DEPARTMENT OF TRANSPORTATION  
CALTRANS DISTRICT 5  
50 HIGUERA STREET  
SAN LUIS OBISPO, CA 93401-5415  
PHONE (805) 549-3101  
FAX (805) 549-3329  
TTY 711  
www.dot.ca.gov

SUBJECT: 1. Request for CTCDC Approval of Two New Word Message Signs  
2. Request for CTCDC Approval and/or Guidance of Existing Signs

SB-101-39.9  
Arroyo Quemada Bridge

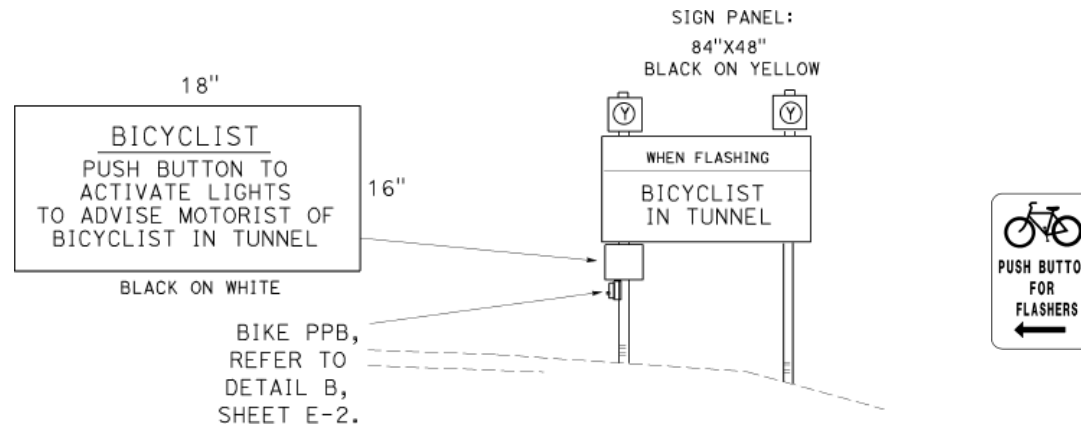
For a bicyclist traveling at 15 mph, it could take them around 20 seconds or more to traverse the bridge or tunnel. Cyclists sharing a lane with high speed traffic are in a vulnerable position, so it is Caltrans District 5's intent to warn drivers when this situation is occurring while still being in compliance with the CA MUTCD. Therefore, we are recommending that the existing "When Flashing" words on the signs be replaced with "Watch For" and that the new signs be fluorescent-yellow green.

1. Caltrans District 5 is requesting CTCDC approval of two non-standard word message signs "Watch For Bicyclist On Bridge" and "Watch For Bicyclist In Tunnel" to replace similar existing signs that say "When Flashing".
2. Caltrans District 5 is also requesting CTCDC approval or guidance on the push button signs. Options include:
  - a. Retain existing non-standard signs "Bicyclist: Push Button To Activate Lights To Advise Motorist Of Bicyclist On Bridge," "Bicyclist: Push Button To Activate Lights To Advise Motorist Of Bicyclist In Tunnel," and a modified R10-26 "Push Button For Flashers" with a bicycle symbol and arrow.
  - b. Replace existing signs with modified R10-25 "Push Button To Turn On Warning Lights" signs. The wording would be the same as the
